BEFORE THE
FEDERAL ENERGY REGULATORY COMMISSION
APPLICATION FOR LICENSE FOR MAJOR PROJECT
SUSITNA HYDROELECTRIC PROJECT

SUSITNA HYDROELECTRIC PROJECT
VOLUME 10B
EXHIBIT E CHAPTER 11
APPENDICES I THROUGH J
AGENCY CONSULTATION

CORRESPONDENCE RELATING TO DRAFT LICENSE REVIEW

DRAFT LICENSE REVIEW

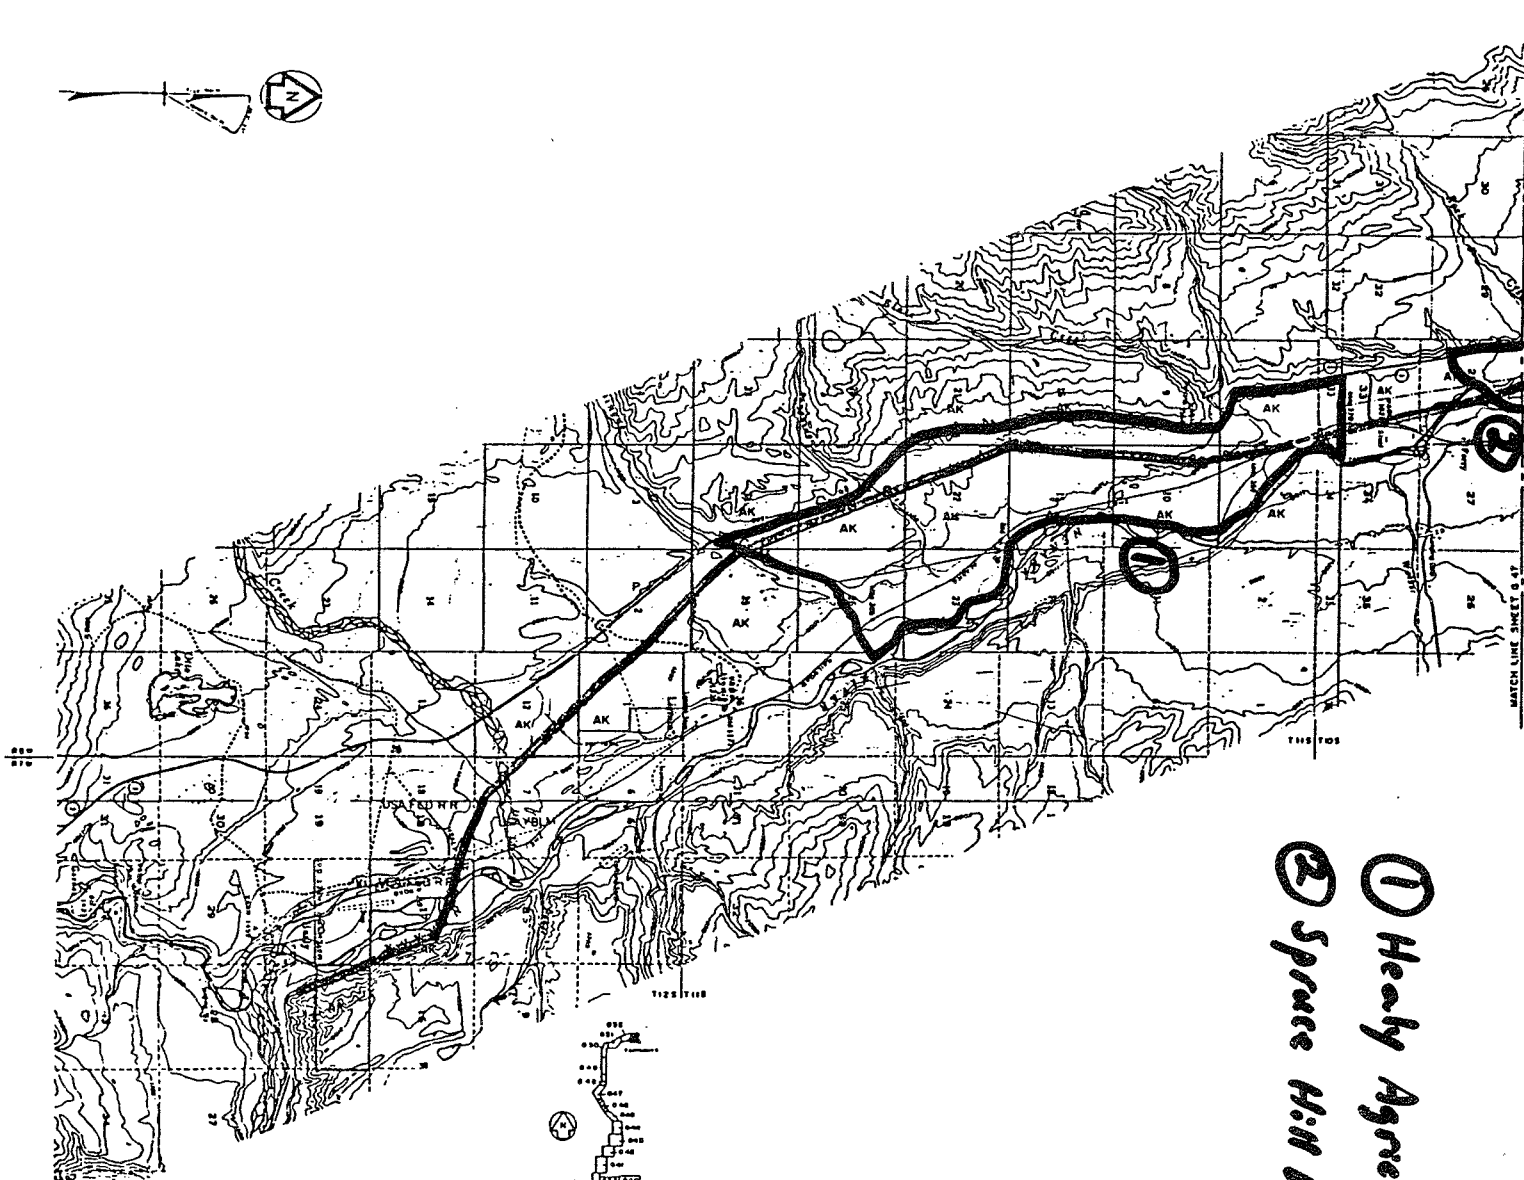
5. Southwind Remote: This is proposed for disposal in F.Y. 1985.
6. Windy Agricultural Sale: Proposed for F.Y. 1985 and a soil survey has already been ordered.
7. Proposed area of Tanana Industrial Site.
8. Goldstream Agricultural Sale: This disposal is proposed for sale in F.Y. 1984 and a soil survey has been done.
9. Alder Creek Subdivision: The proposed right-of-way line appears to be in close proximity to this subdivision which has already been offered for sale.
10. Northridge Subdivision: Portions of the proposed line appear to abut and/or cross into ASLS 81-214. All lots within this subdivision were sold in the last lottery and placement of the line in proximity to the subdivision would greatly effect the viewshed from the subdivision.

The overall District concern is the impacts the proposed right-of-way will have on land disposal actions and proper land management practices. Particularly, we would like to know why the new transmission line couldn't be placed adjacent to the existing transmission lines to lessen impacts? I am sure other questions and concerns will become evident as the project becomes more finalized. We look forward to working with you on the resolution of these conflicts. Please keep us informed on the progress of your studies in these matters.
